Technical Car Construction Regulations Changes for 2019 Additional Information and Clarifications

Version 2.0 (Published) – 6th February

Document compiled on behalf of BriSCA F2 by: **Adrian Blackwell**
BriSCA F2 Chief Technical Consultant

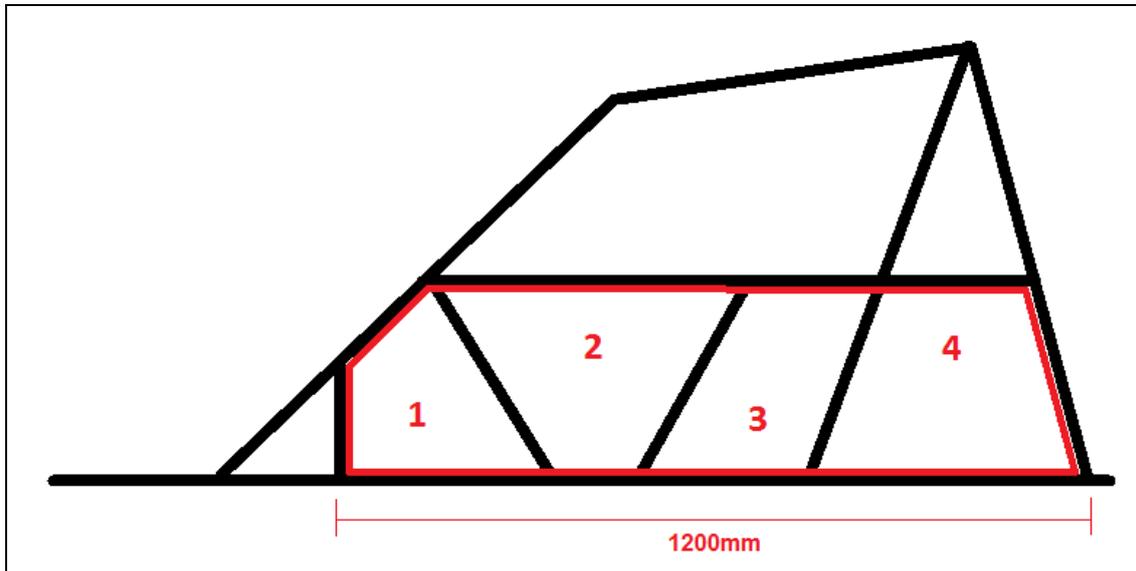
UPDATE: The stacking of more than two lengths of tube together, thus forming a “wall”, is not permitted (unless expressly required, e.g. in the construction of nerf rail and bumper blades). Where multiple lengths of tube are being used together in car construction, e.g. a protective frame, then a minimum gap between tubes equal to twice the larger width/diameter of the tube being used must be maintained. E.g. a 50mm gap must be maintained between multiple sections of 25mm CHS, or 100mm between sections of 25x50mm RHS.

Updated Technical Diagram 01

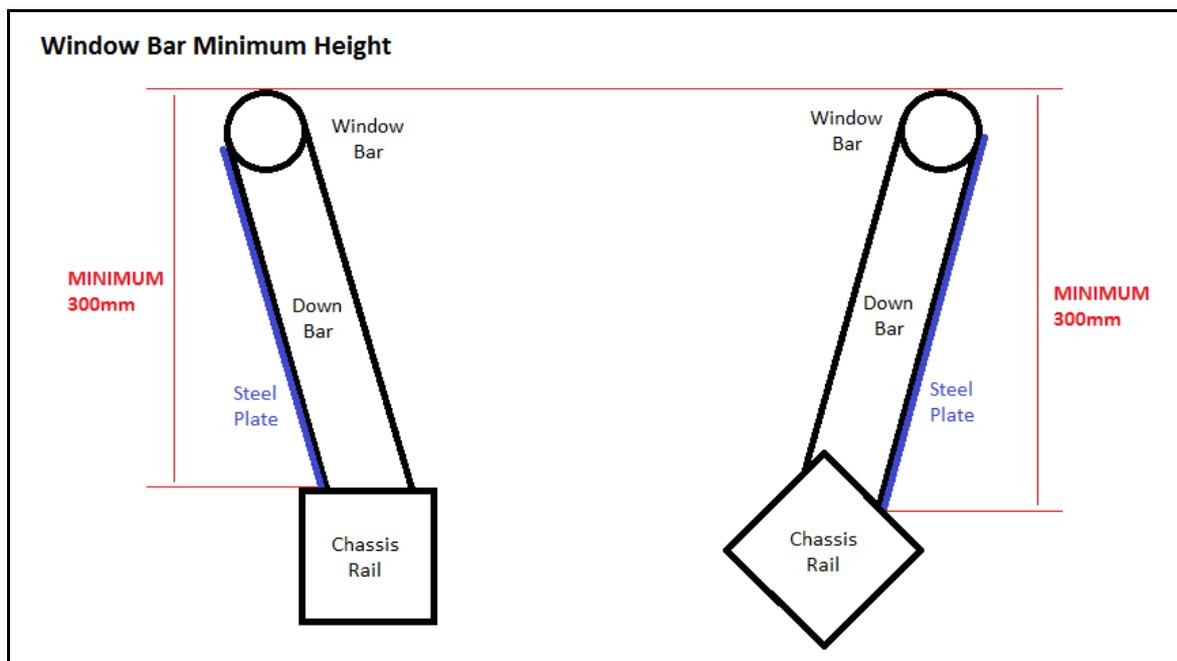
UPDATE: At the request of drivers, a maximum number of 4 pieces of plate may be used on each side of the car, 1 per aperture (see updated diagram below). A single piece of plate may cover 1 or more apertures, but multiple plates must not be joined to each other to cover a single aperture.
 - The plate **MUST** be fitted to the outside of the roll-cage/window-bar/down-bars, or inset **NO MORE** than a **MAXIMUM** of 5mm from the outer edge of the tube.
 - The plate (each plate section) **MUST** be fully welded to the roll-cage structure along the full length of each of its sides (in the same manner as the existing rear panel).
 - The area covered by the plate **MUST** measure at least a **MINIMUM** of 1200mm in length, from the rearmost point where the rear roll-cage pillar meets the chassis rail, horizontally, to the vertical plane where its front-most point meets the chassis rail.

UPDATE: This measurement will be taken from the rear of the rear roll-cage post, to the front of the foremost tube/post to which the plate is welded. This is therefore not necessarily the actual size of the plate but the length of the solid side including the tube it is welded to (exactly like the measurement of the roof plate).

- **UPDATE:** It is permitted to cut the side plates around rear shock-absorber mounting brackets, if required. The plates do **NOT** need to be welded to the brackets. A **MAXIMUM** 15mm clearance between the plate and mounting bracket is permitted. Where inboard shock-absorbers are installed then the maximum clearance measurement is taken with the “rocker” at its highest point of travel.

- **UPDATE:** It is permitted to cut a hole in each side plate for the fitment of a rear anti-roll bar if required. The hole on each side of the car must be no larger than a **MAXIMUM** size of 75mm in diameter, or 75mm square.
- See Technical Diagram 01 for a visual guide to the above changes.

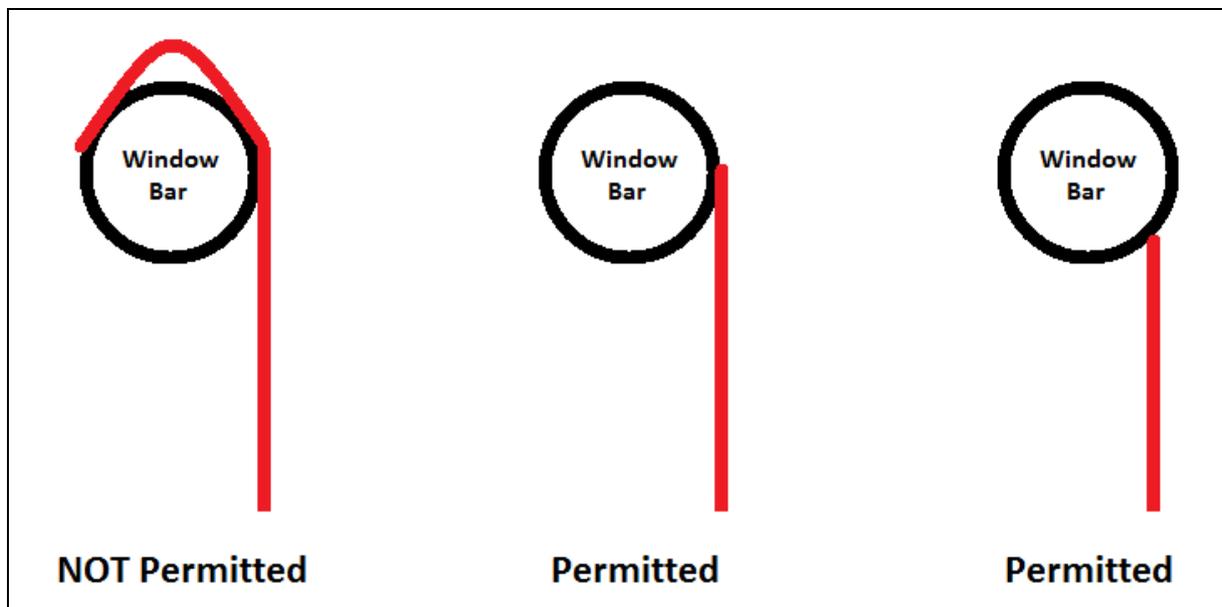
- **UPDATE:** It is NOT permitted to roll the steel side plate(s) up and over the window bar(s) in order to gain additional height in cars where the window bars are currently installed very low down. The window bars in all cars need to conform to the minimum height in order to provide a minimum level of protection for all drivers. It is understood that this affects very few current cars. (See diagram below)

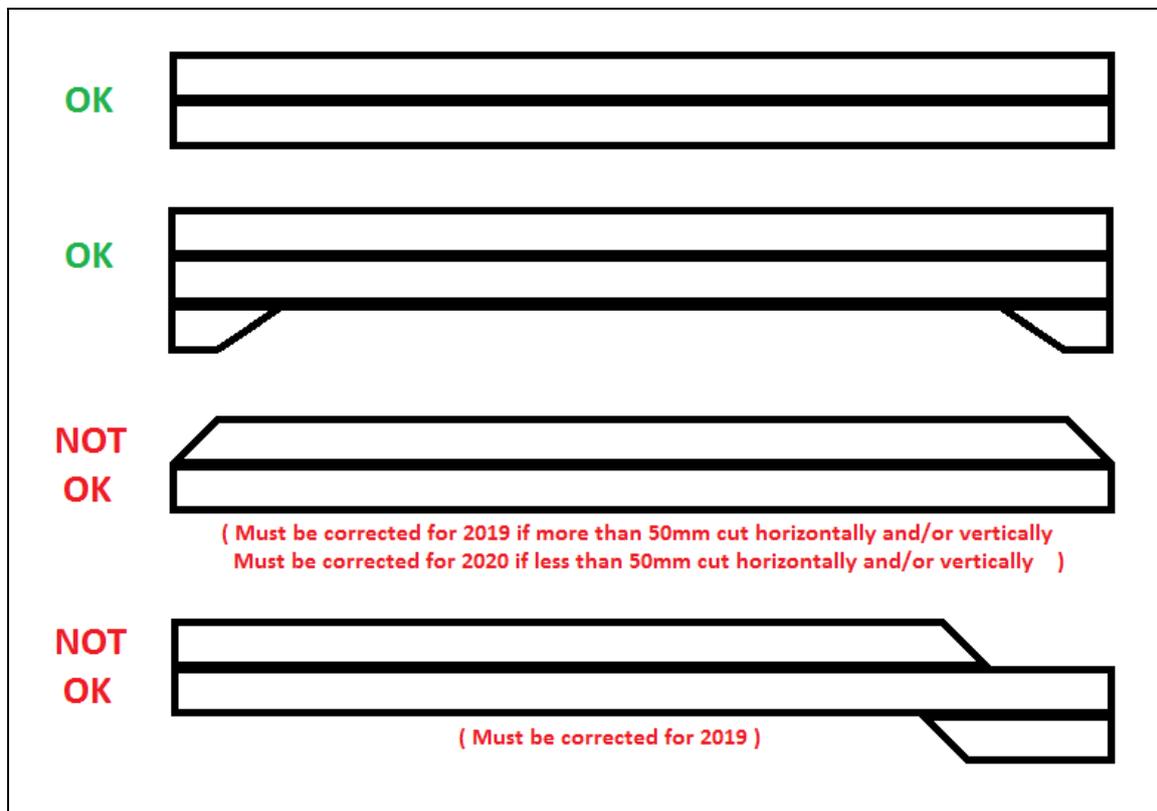
- The painting, coating, or protection of the inlet manifold, is NOT permitted with effect from 1st January 2020.
- The painting/coating of non-ferrous components on the Pinto engine, e.g. the cover behind the end of the crankshaft, or the distributor body, IS permitted.

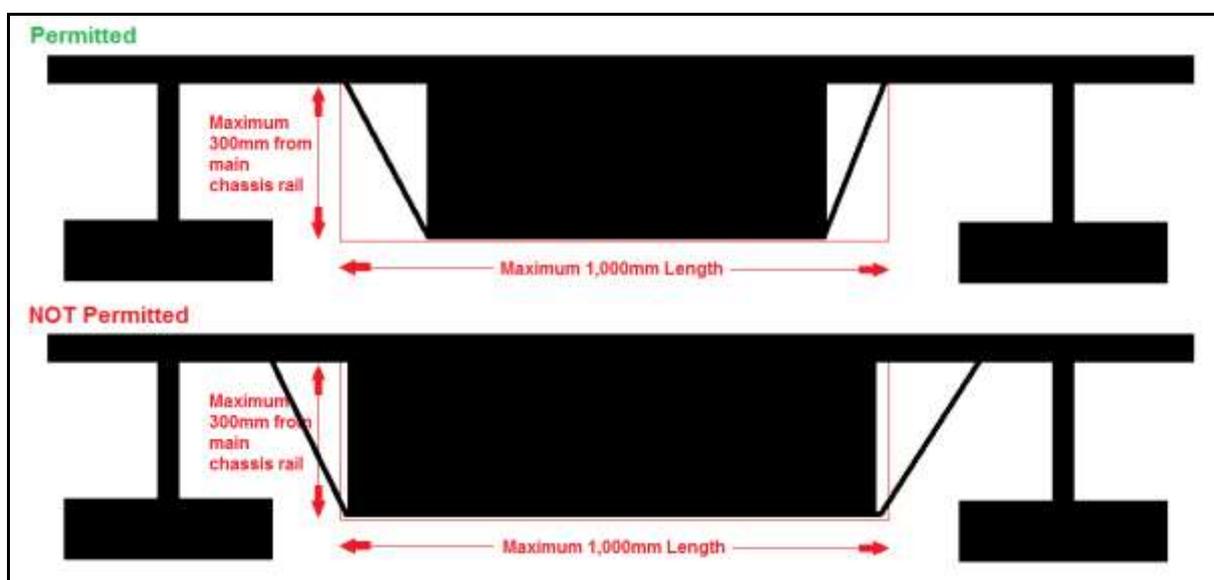
- A clearer definition of the “space-frame undercarriage” of the car will be given. The undercarriage must be constructed from hollow section (CHS, SHS, RHS, OHS) with metal panel-work as required. The construction of the undercarriage from steel plate is not permitted.

- **UPDATE:** Further to the clearer definition of the undercarriage, it is further clarified that...
 - The construction of offset, inset, outset, or other non-symmetrical designs of undercarriage are not permitted.
 - The undercarriage must be symmetrical about the centre-line of the car when viewed from the front and rear, with any lower rails and floor sections being equal in depth from the main chassis rails.
 - **It is believed that this requirement does not adversely affect any current cars**, however, BriSCA F2 wish to restrict proposed development in this area that is deemed to be at odds with the fundamentals of “stock car racing” and the spirit of the existing regulations.

Nerf Rails – Tapering

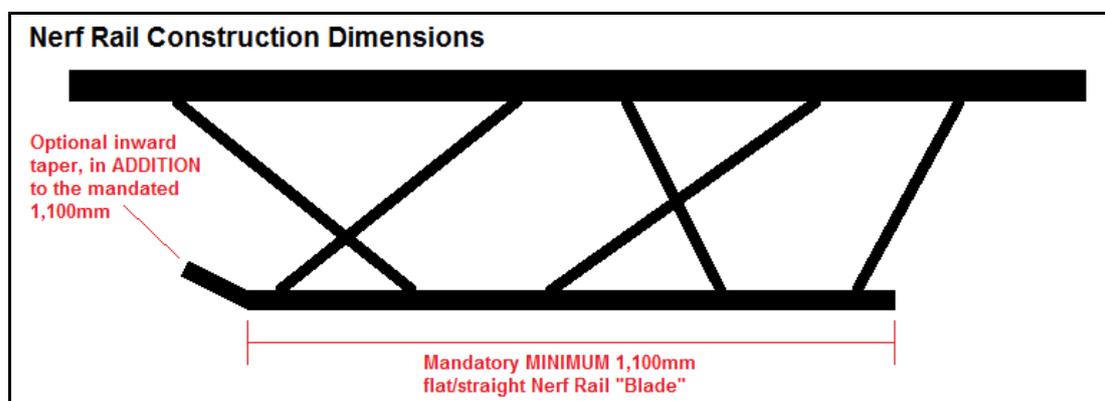
- The tapering-in of the front ends of the nerf rail blades, to prevent hooking up on fence-posts or other cars, will be expressly permitted as this is seen as a benefit to drivers in terms of avoiding damage and thus reducing cost.

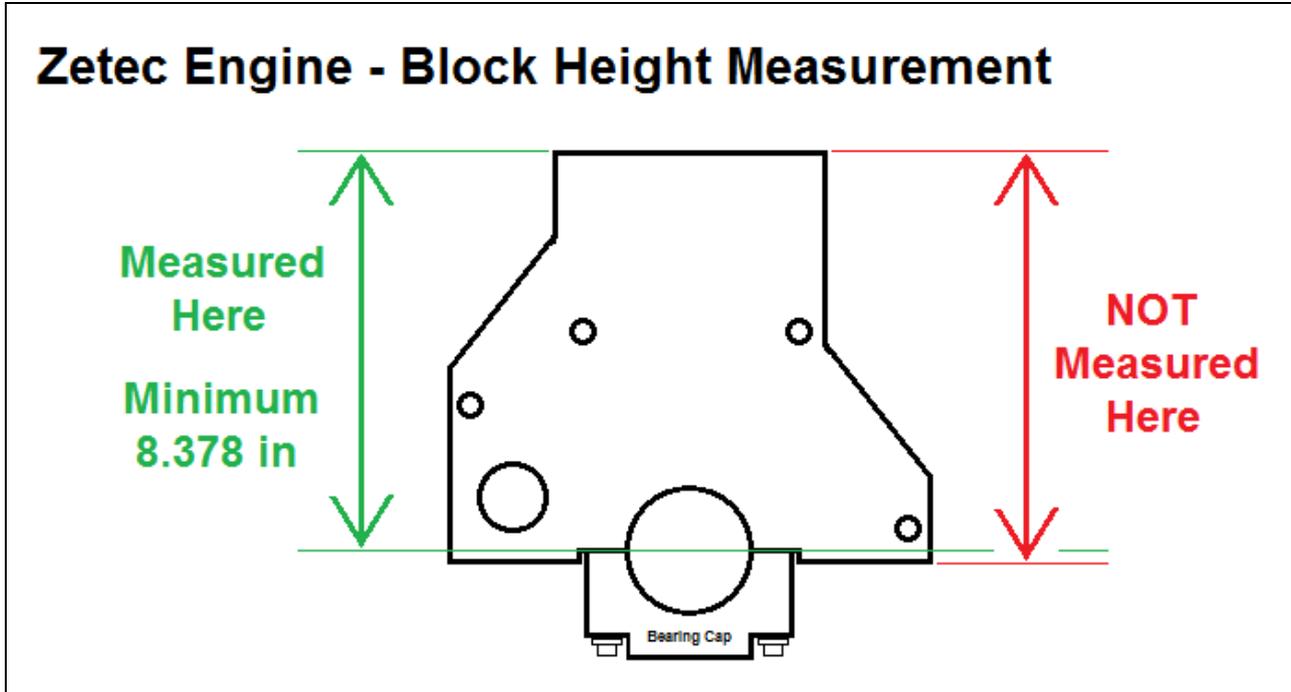
- **Ignition Amplifier (Black Box)**
 - The only permitted ignition amplifiers are the following original and direct replacement units:
 - Motorcraft The original unit as installed and fitted by Ford

- Intermotor Direct replacement
 - Lucas Direct replacement
 - Other units have not been tested, and cheap copies may not meet original Ford specifications.

Zetec Engine – Camshaft Timing

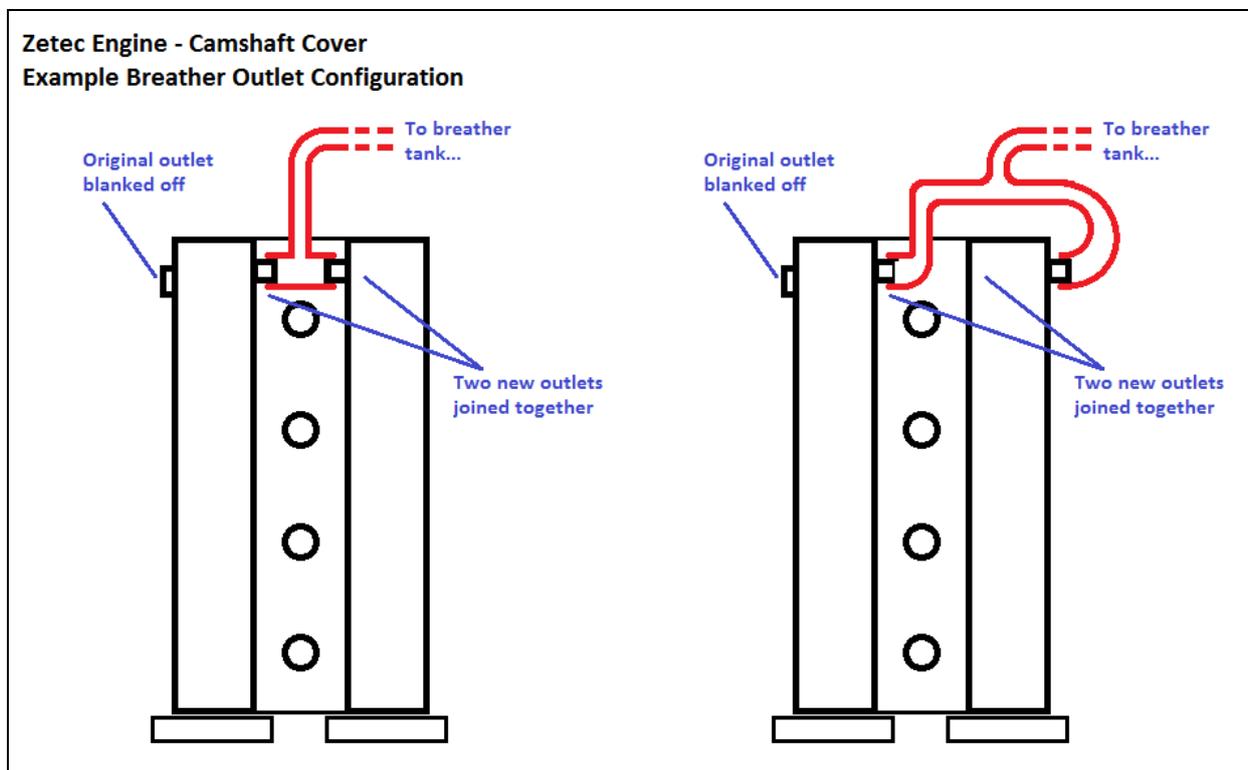
- Concerns have been raised over camshafts moving from their standard timing due to the timing pulleys simply being a friction push fit.
- A method of “locking” the timing pulleys to the camshafts has now been approved for use:
 - Locking of timing pulleys to the camshafts is now permitted through the use of grub screws tapped in to the pulleys and the ends of the camshafts.
 - The grub screw(s) must be concealed behind the head of the standard flange-head bolt used to secure the pulley to the camshaft.
 - The standard flange-head bolt used to secure the pulley to the camshaft must be retained.
 - A maximum of 2 tapped holes will be permitted in each timing pulley
 - A maximum of 4 tapped holes will be permitted in the end of each camshaft (to allow for the resetting of the timing to the correct position following any permitted skimming of the cylinder head)
